Evidence Book 13

Township of Guelph/Eramosa Noise Impact Review Document Book

Noise Impact Review Document Book Index

**Re: Peer Review, Acoustical Study
Hidden Quarry
Novus Project No. 12-0258**

Fig 4.1

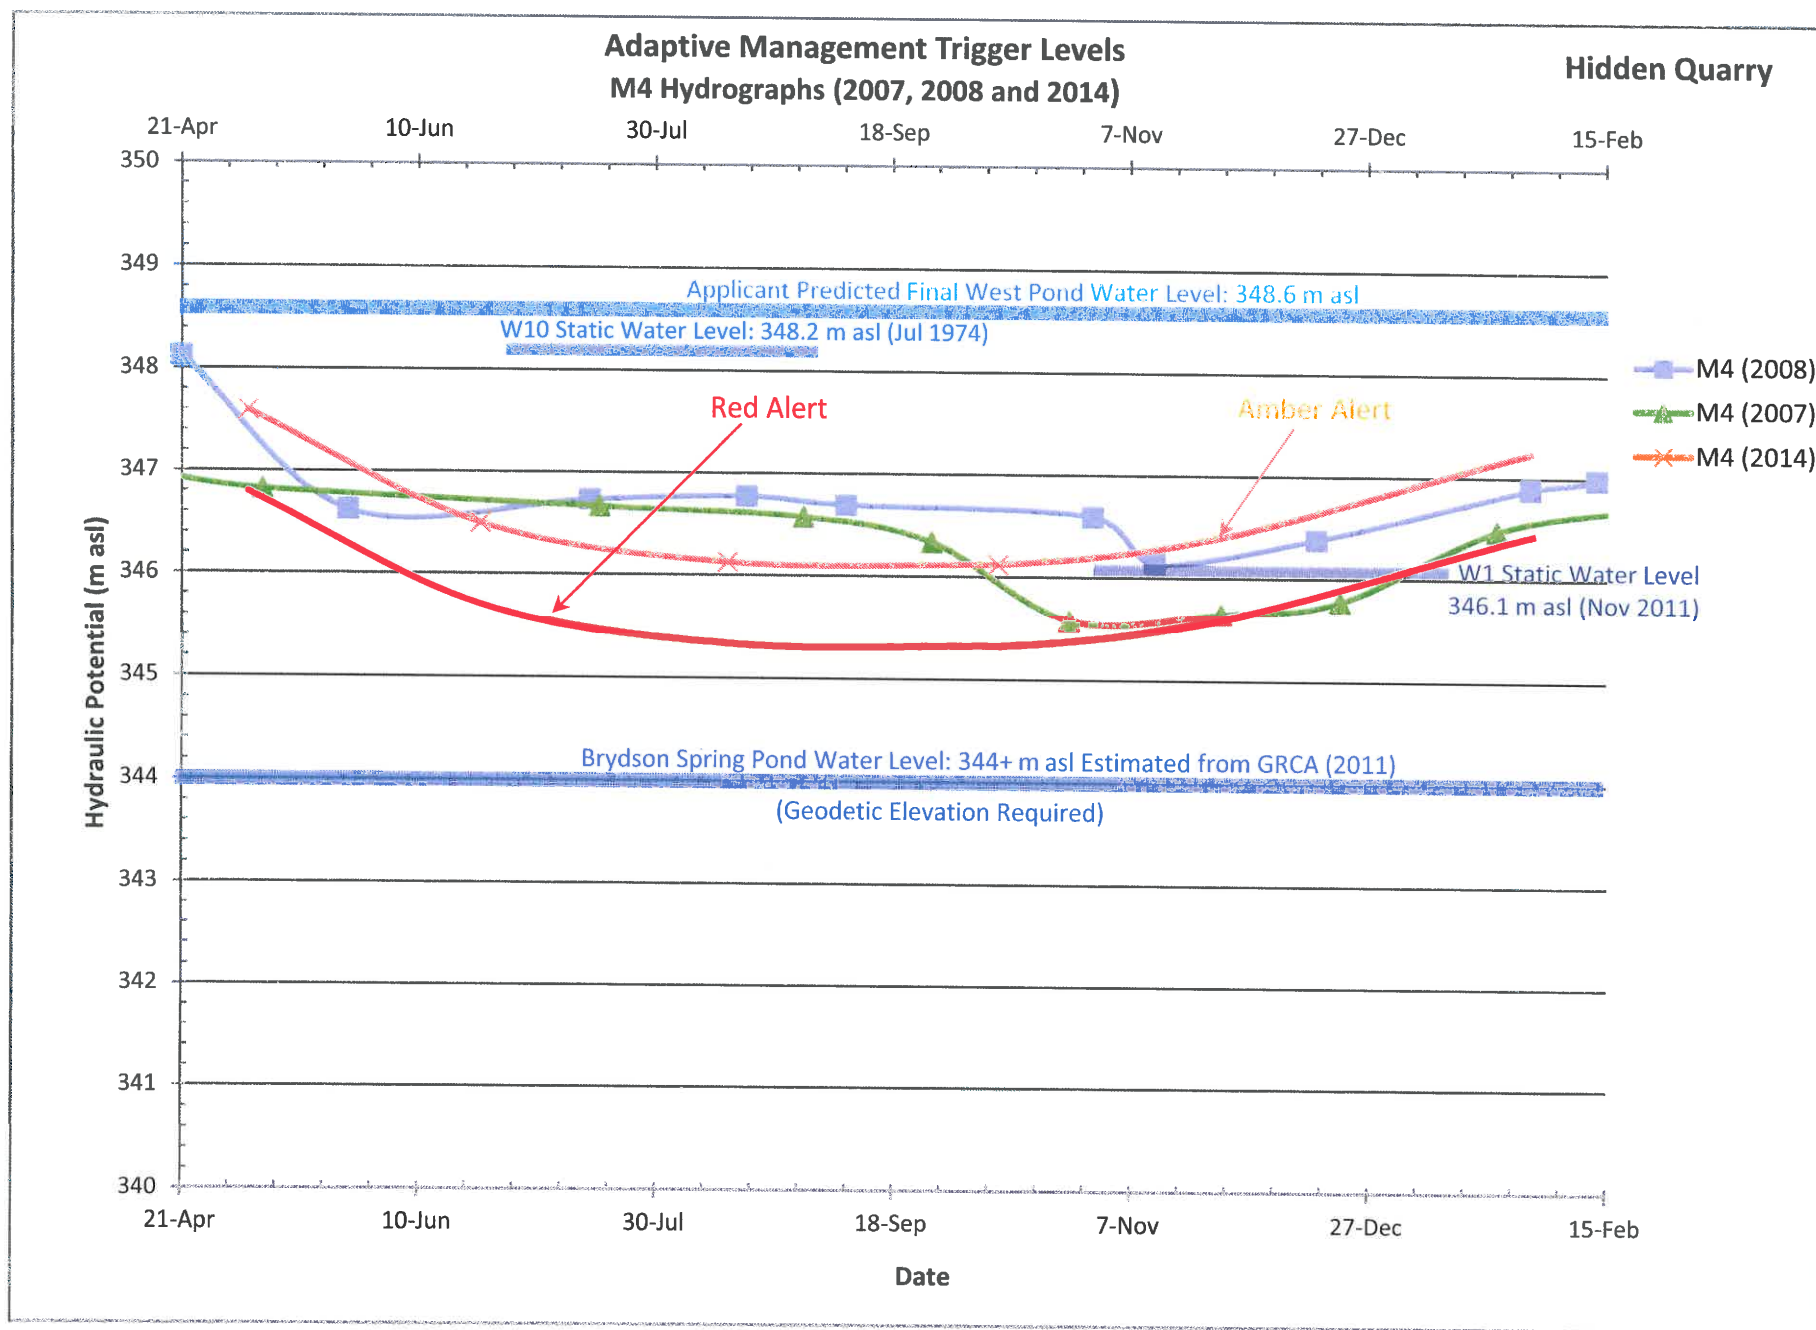
Fig 4.1 enclosed shows seasonal Amber and Red Alert hydrograph trend lines to provide early warning of dry season drawdown issues.

Fig 4.2

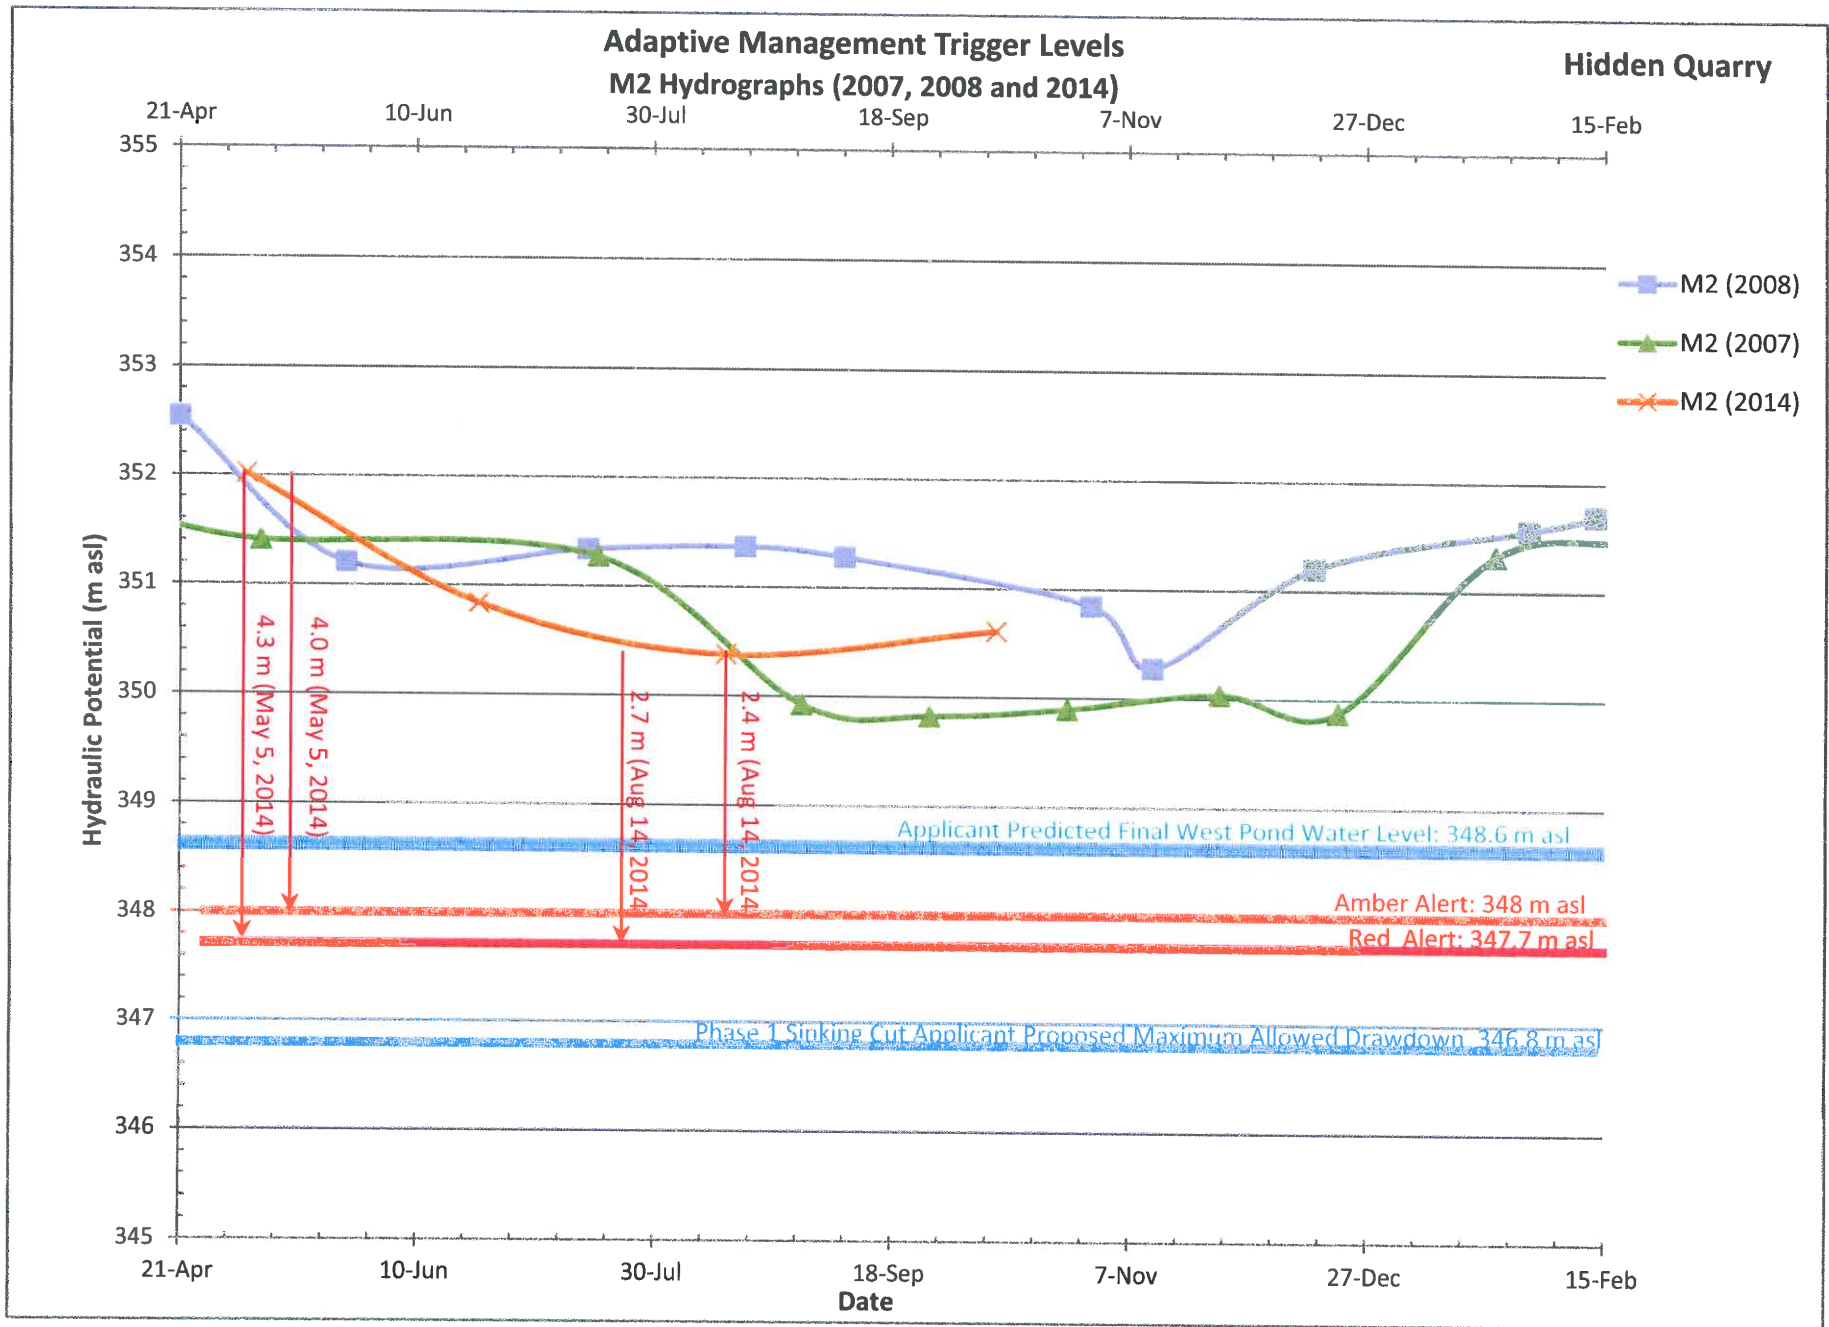
These Alerts have been adjusted downwards to reflect the operational Site Plan assumptions (Fig 4.2).

Fig 4.2 The M2 Adaptive Management Trigger levels are based on the Applicant's Site Plan proposed pit floor and operating water level drawdown requirements. The Amber Alert drawdown level in 2014 decreased from 4.0 m in May to 2.4 m in August.

Fig 4.3

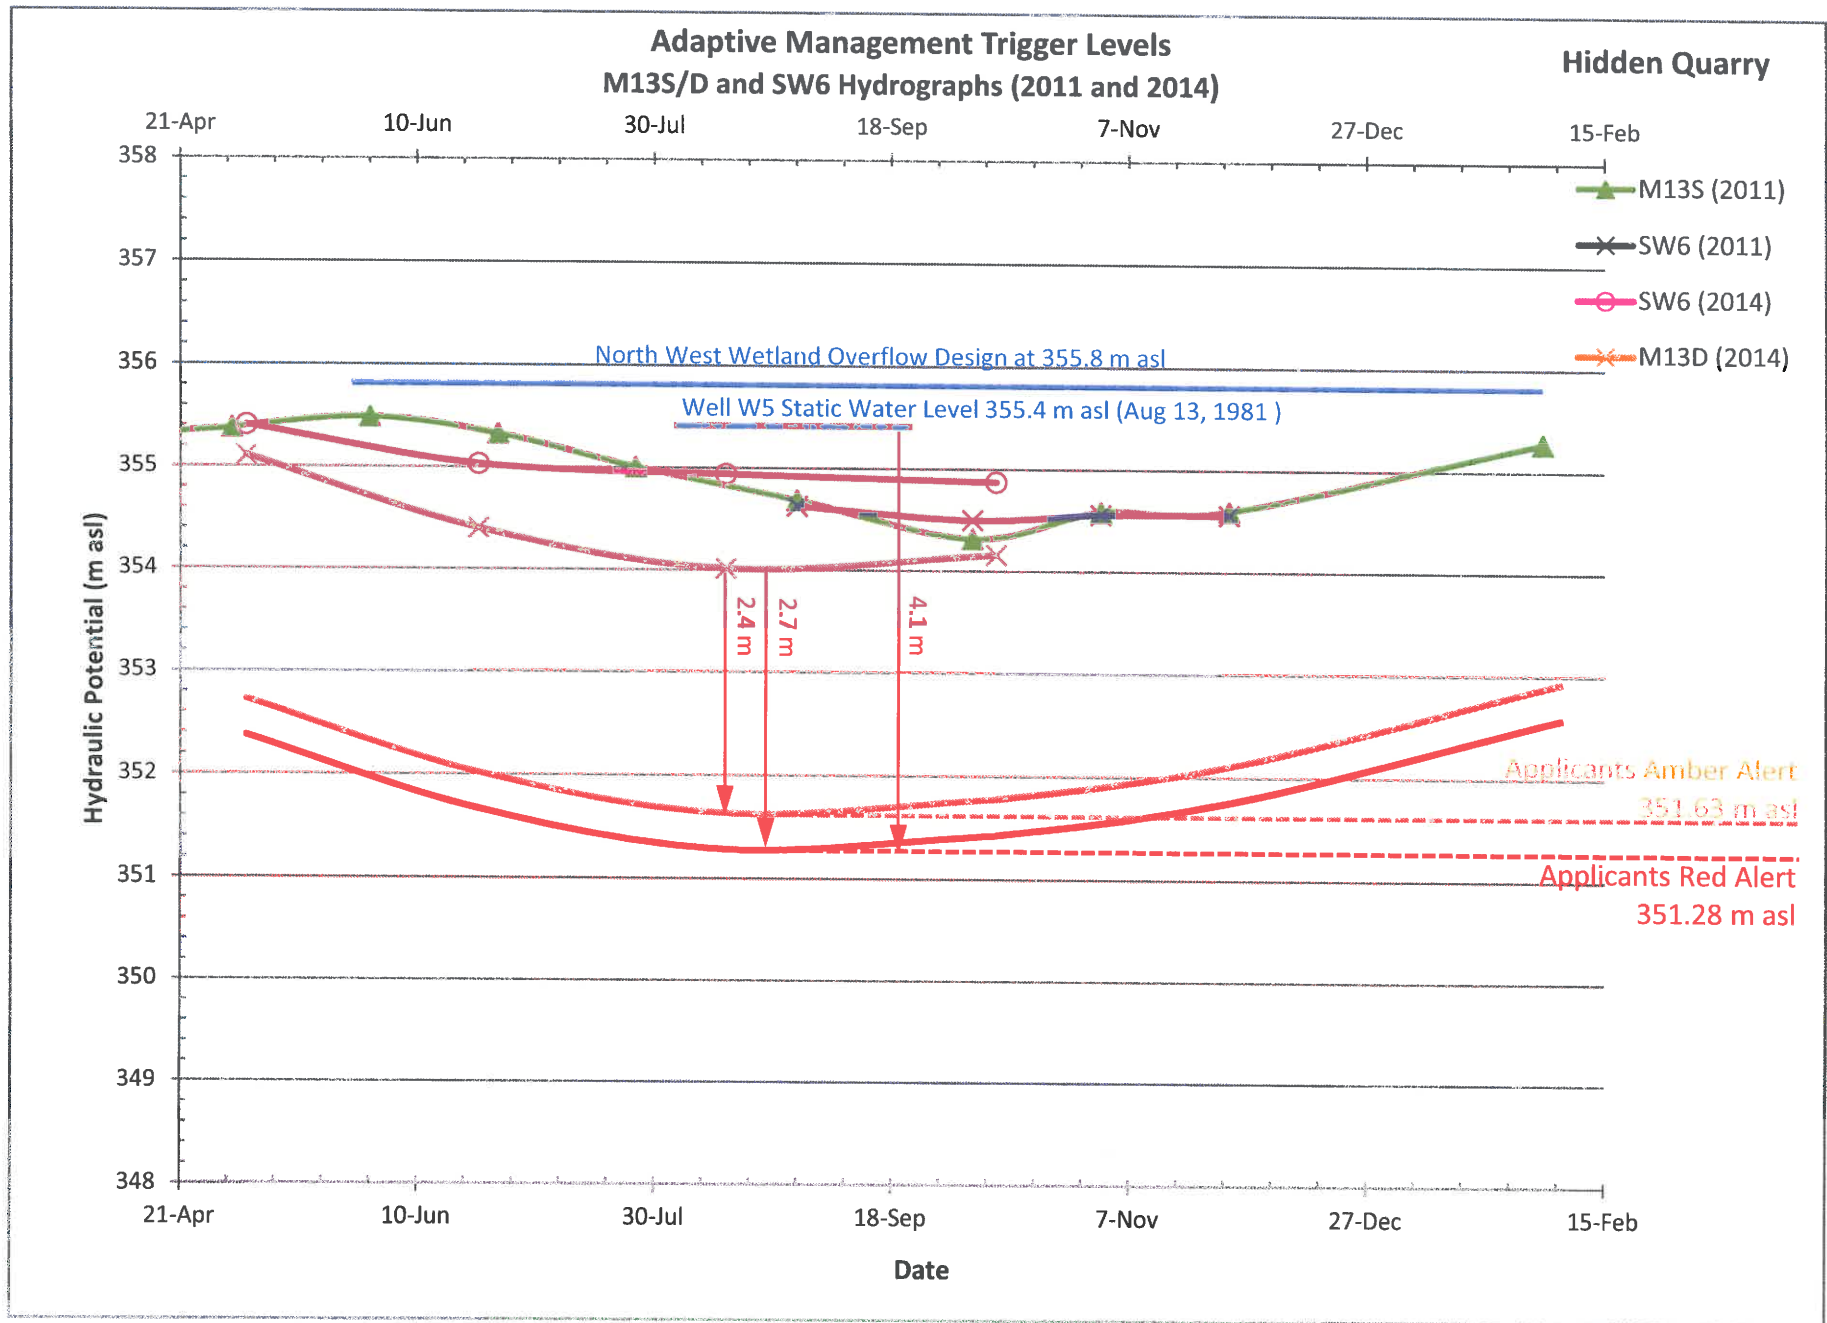
The Applicant has set the following trigger levels (Fig C.4, June 10, 2014) for M13D and pg 4 of 5 March 19, 2015 Site Plan version (Fig 4.3).

Fig 4.3 The Applicant proposed Amber and Red Alerts for Monitor Well 13D are plotted on this hydrograph. These alerts show a 4.1 m drawdown at nearby W5 based on static water levels at the time of W5 completion.

Fig 4.4

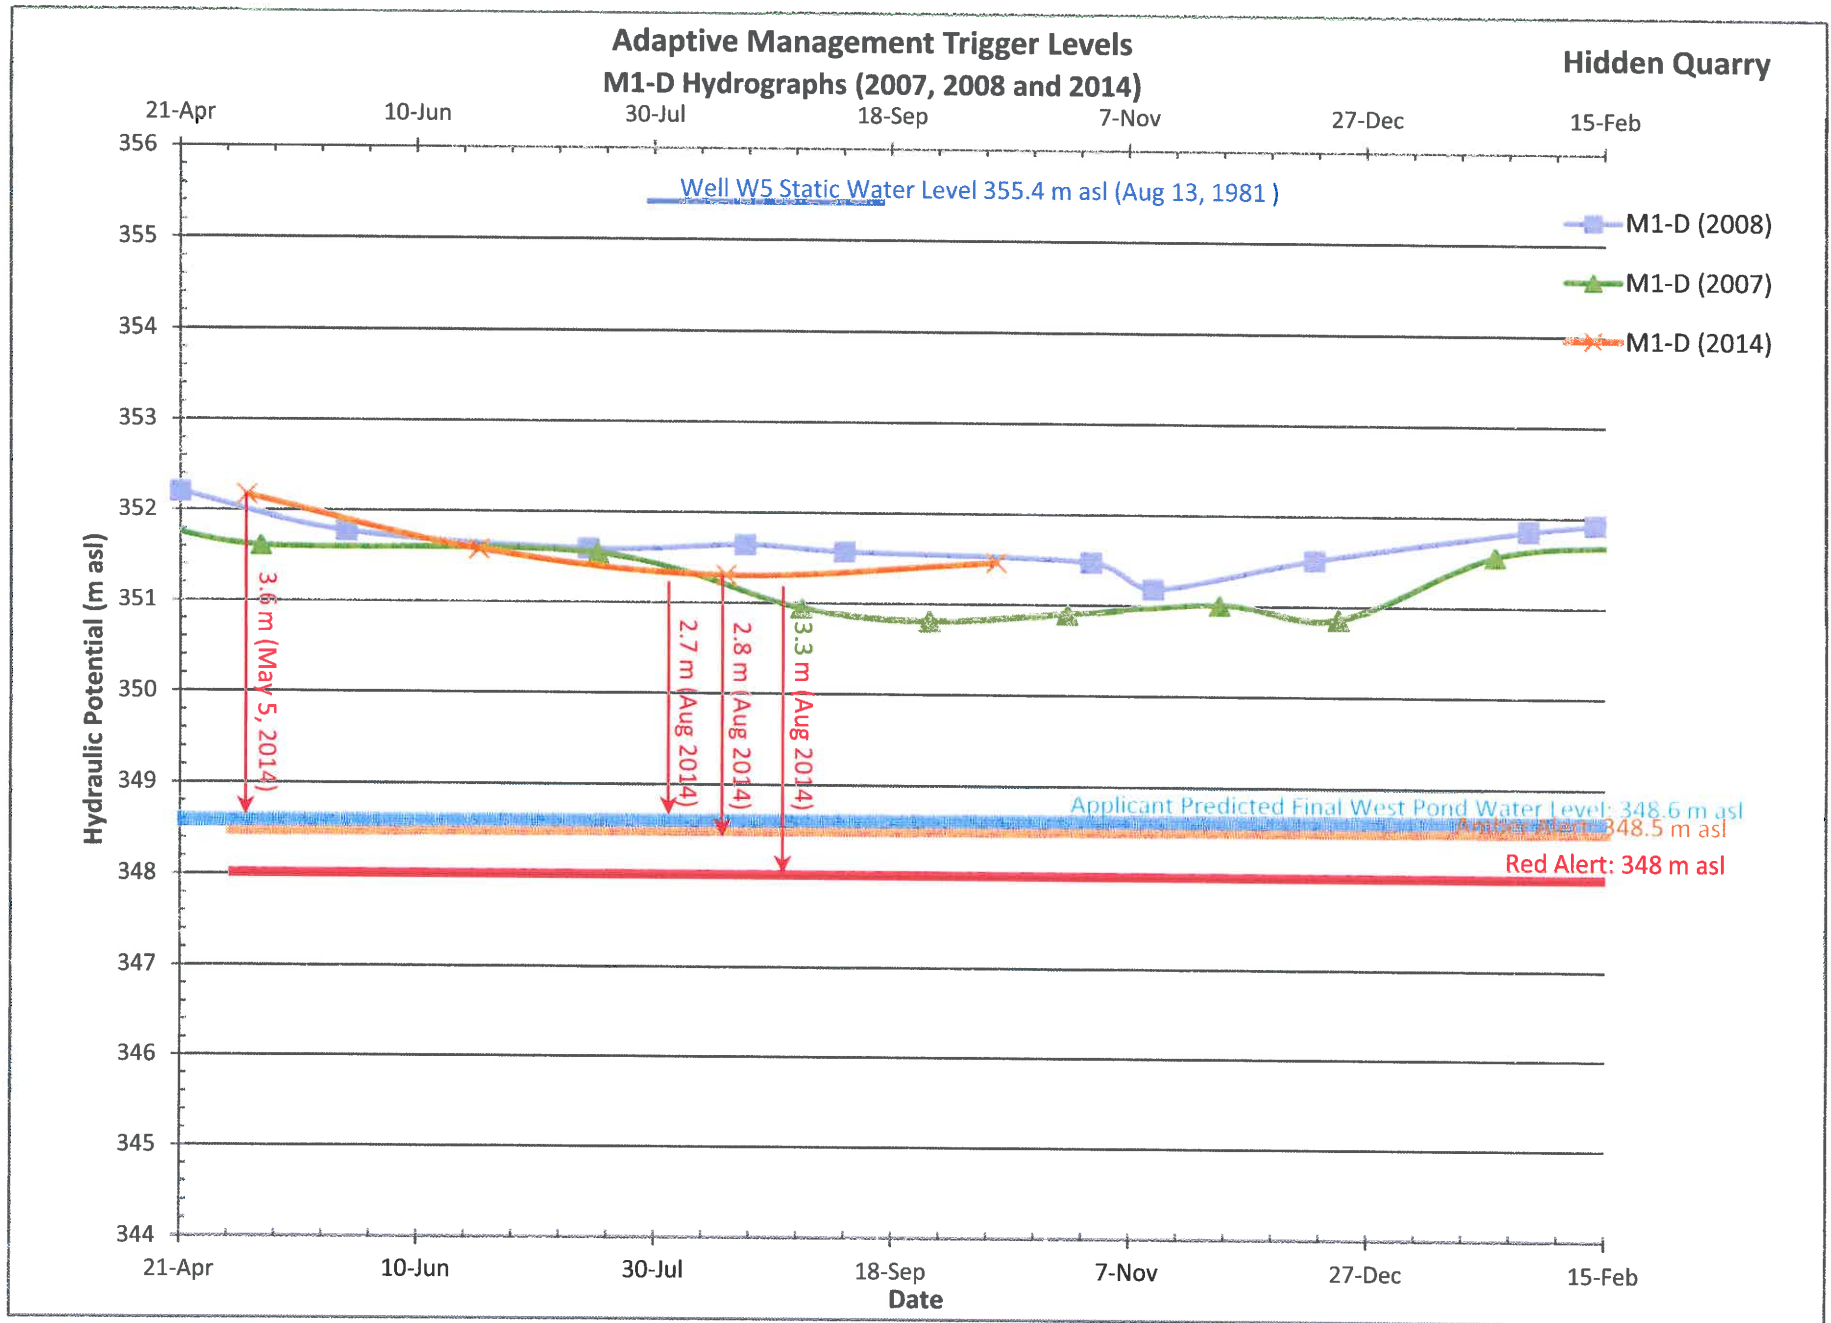
Fig 4.4 Actual 2014 year seasonal drawdowns to the Applicant predicted (suspect) final west pond water levels are estimated at 4 m in May and at 3.3 m in August for M1D. The bottom of the screen at M1D is at about 348 m asl. This monitor will have to be replaced with a deeper screened base at about 327 m asl to ensure an appropriate operating range is available for Alert monitoring.
